TENNESSEE VALLEY AUTHORITY

Director of Nuclear Reactor Regulation
Attention: Ms. E. Adensam, Chief
Licensing Branch No. 4
Division of Licensing
U.S. Nuclear Regulatory Commission
Washington, D.C. 20555

In the Matter of the Application of) Docket Nos. 50-390
Tennessee Valley Authority) 50-391

Response to August 22, 1984 letter
from E. Adensam to H. G. Parris

TABLE 3.3-1 (Continued)

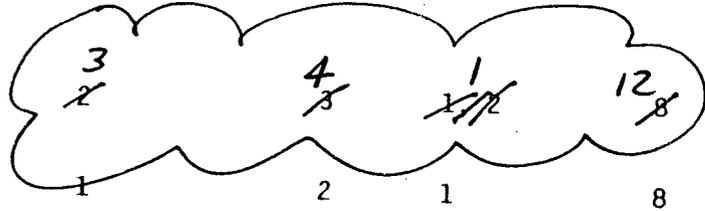
- b. Item 20, the minimum channels operable for interlock P-10 for Mode 1 conflicts with FSAR Section 7.2.1.1.2. That is, when coming down in power it takes 3 out of 4 P-10 channels to reinstate the intermediate range high neutron flux trip and the low power range neutron flux trip. Item 20 shows 2 out of 4.

Table 3.3-1 Functional Unit 20.e (TS page 3/4 3-4)

CHANNELS TO TRIP should be 3, not 2. Three bistables must be energized to Auto Enable the "Low Power" Reactor Trips.

Table 3.3-1 Functional Unit 20.e and ACTION STATEMENT 12 (TS page 3/4 3-4 and TS page 3/4 3-8)

MINIMUM CHANNELS OPERABLE should be 4, not 3. Three channels are required to Auto Enable, thus 4 must be OPERABLE to meet single failure criteria. ACTION STATEMENT 12 has been added to reflect appropriate actions to different conditions. With less than 4 channels OPERABLE and the "Low Power" Reactor Trips blocked a plant shutdown below the P-10 setpoint (10 percent) is not warranted since the capability to enable the "Low Power" Reactor Trips may be lost. Since the P-10 bistables must be energized to enable the "Low Power" Reactor Trips, removing power from the bistables will not reinstate the trips. With less than 4 channels OPERABLE and the "Low Power" Reactor Trips not blocked, any P-10 failure will not block the "Low Power" Reactor Trips since it also takes coincident manual blocking (4 separate handswitches) to defeat them. Thus, the appropriate action is to restore the inoperable channels to OPERABLE status before blocking the "Low Power" Reactor Trip.

Table 3.3-1 Functional Unit 20.e (TS page 3/4 3-4) and Table 4.3-1
Functional unit 20.e (TS page 3/4 3-13)

·APPLICABLE MODES should have mode 2 deleted. There is no consequence of being in mode 2 with P-10 operable. The Auto Enable of the "Low Power" Reactor Trips and the input to P-7 will take place at 10-percent Reactor power which is mode 1. And, as discussed above, the "Low Power" Reactor Trips once enabled cannot be blocked without manual action. A failure which would cause a P-10 input to P-7 in modes 2 and below could only enable the "At Power" Reactor Trips and thus has no adverse safety effect. Any P-10 malfunction that could make the Source Range detectors inoperable in mode 2 and below would be readily detectable via MCR indications and alarms and would be handled in accordance with Limiting Condition for Operation 3.3.1 (item 6 table 3.3-1) covering the Source Range detectors.

Actual Performance

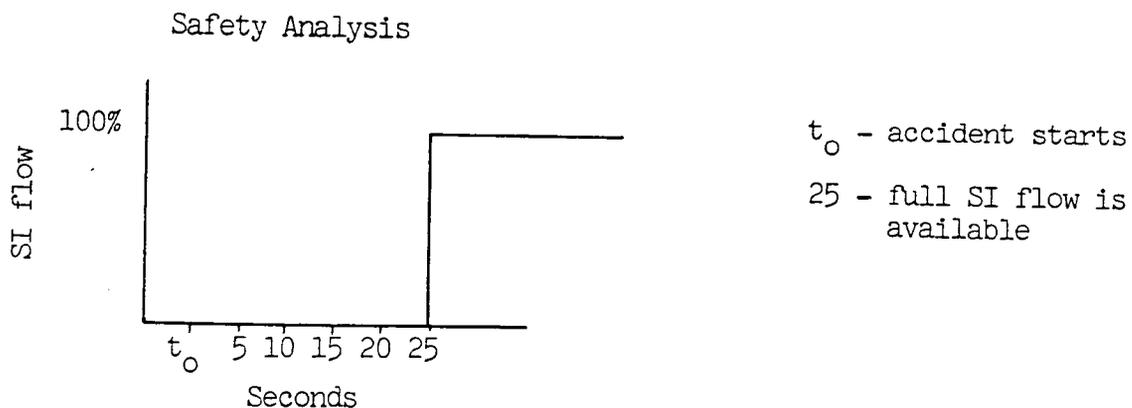
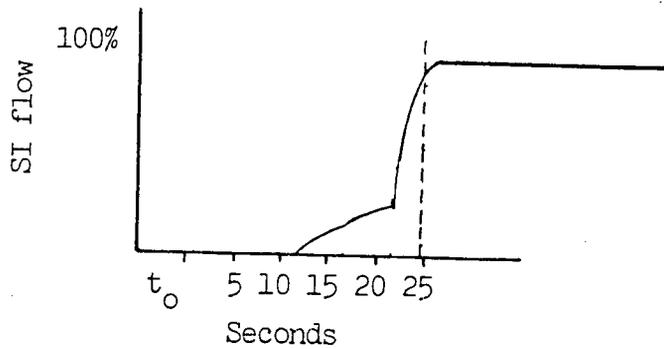
3. Reactor Trip System Instrumentation Response Times, Table 3.3-2 (page 3/4 3-9)
- b. Section 15.3.1.2 of the FSAR assumed a SI delay of 28 seconds, yet the TS response time is listed as 27 seconds. Please explain. Furthermore, it should be noted that 15.4.1.1.5 states that the time to reach the SI setpoint and to generate an SI signal is 1.5 seconds. How do these values correspond to Table 15.4-1 of the FSAR which lists an SI signal occurring as soon as .85 seconds and pump injection 25 seconds later.

Section 15.3.1.2 of the FSAR correctly states that for the small break LOCA a delay of 25 seconds was included in the analysis before SI flow was initiated. This 25 second delay starts when the monitored parameter reaches the trip setpoint and ends with the initiation of full SI flow at the end of 25 seconds. During the 25 second delay, no high pressure SI flow is assumed available. For large break LOCA, Table 15.4-1 of the FSAR shows 0.85 seconds for the monitored parameter to reach the trip setpoint, the SI signal has not been generated at this point. Then, 25 seconds later SI flow is initiated. The 25 second delay accounts for SI signal generation, diesel start time and pump start time as described below.

The 27 seconds in the technical specifications is consistent with the 25 seconds in the LOCA analysis due to the conservative assumption of no SI flow for 25 seconds. In reality SI flow starts well before the 25 seconds assumed in the analysis. The figures below provide a comparison of the analysis assumption vs actual performance.

- t_0 - accident starts
- 2 - SI signal is generated
- 12 - diesel is up to speed and charging pumps start
- 17 - charging pumps at full flow, SI pumps start
- 22 - SI and charging pumps at full flow, RHR pumps start
- 27 - Full SI flow

By taking no credit for SI flow before 25 seconds the accident analyses are consistent with the technical specification requirements for the emergency core cooling system.

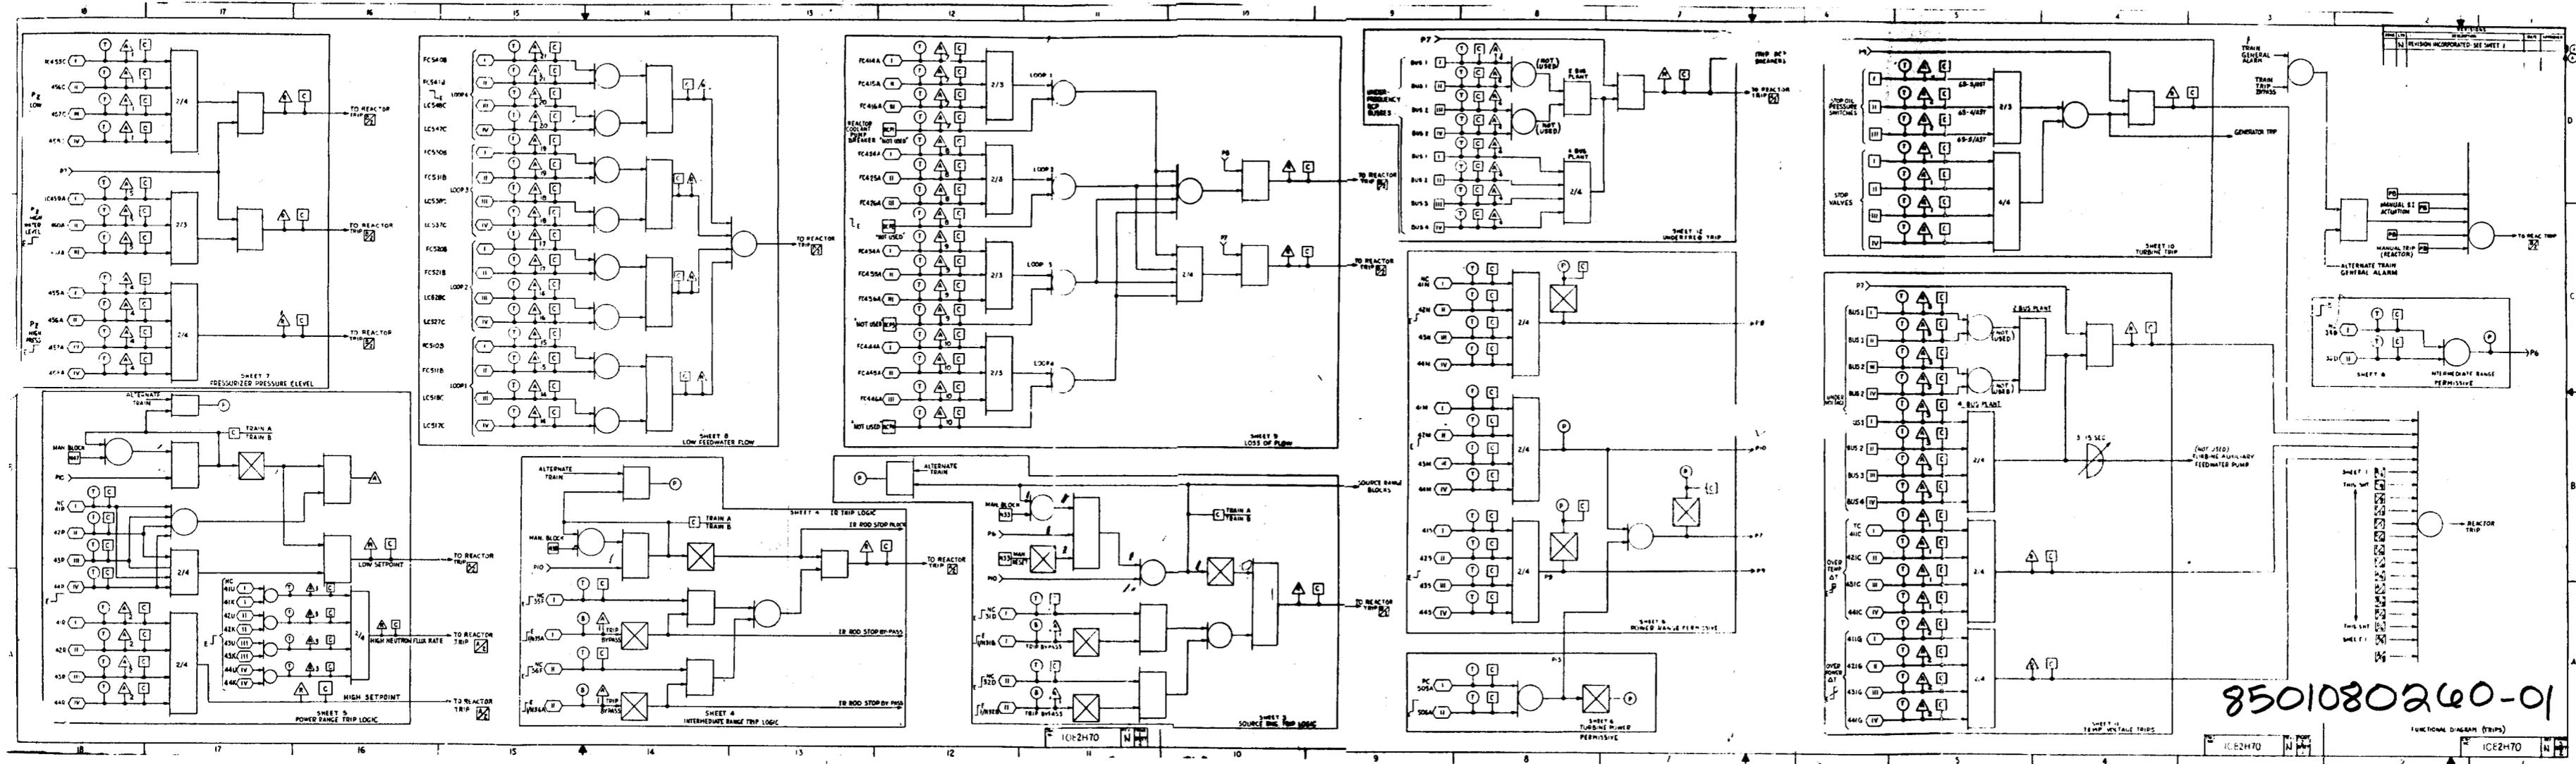
For rod withdrawal accident at subcritical conditions, the staff is under the impression that reactor trip is initiated by the power range neutron flux trip. However, the power range neutron flux trip needs only to be operable in modes 1 and 2 according to the Technical Specifications. Please explain this apparent discrepancy. If your explanation takes credit for either the intermediate range or source range trips, then the setpoint methodology will have to be amended to reflect this.

If the NRC staff is concerned about bank withdrawals in Modes 4 or 3, then the technical specifications afford protection by requiring two source range trip channels to be operable. The transient would also be less severe than the case described above. The reactor coolant temperature would be lower, improving the parameters described above. The reactor would be at least 1-percent Delta-K/K subcritical as specified by Standard Technical Specifications. The trip setpoint on the source range channel is approximately six decades lower than the power range low setpoint assumed in the safety analysis.

A safety analysis trip limit of 35 percent power range was assumed. This value corresponds to approximately 1×10^{-4} amps on the intermediate range detector. The trip setpoint on the source range detector is 1×10^5 counts per second. This value corresponds to approximately 5×10^{-10} amps on the intermediate range detector. The upper limit on the source range detector is 1×10^6 counts per second and the lower limit is 1 count per second. The total channel error has been calculated to be 10.8 percent of span. This is less than one decade. The source range trip setpoint of 1×10^5 counts per second ensures that even with the worst case error the trip will occur before the source range detector goes offscale high.

The technical specifications are consistent with the limiting safety analysis for an uncontrolled rod cluster control assembly bank withdrawal event. The technical specifications also provide protection for less limiting bank withdrawals in Modes 3 and 4 by requiring that two source range trip channels be operable. The source range trip setpoint is consistent with calculated channel error and is approximately six decades more conservative than the limiting safety analysis assumed setpoint.
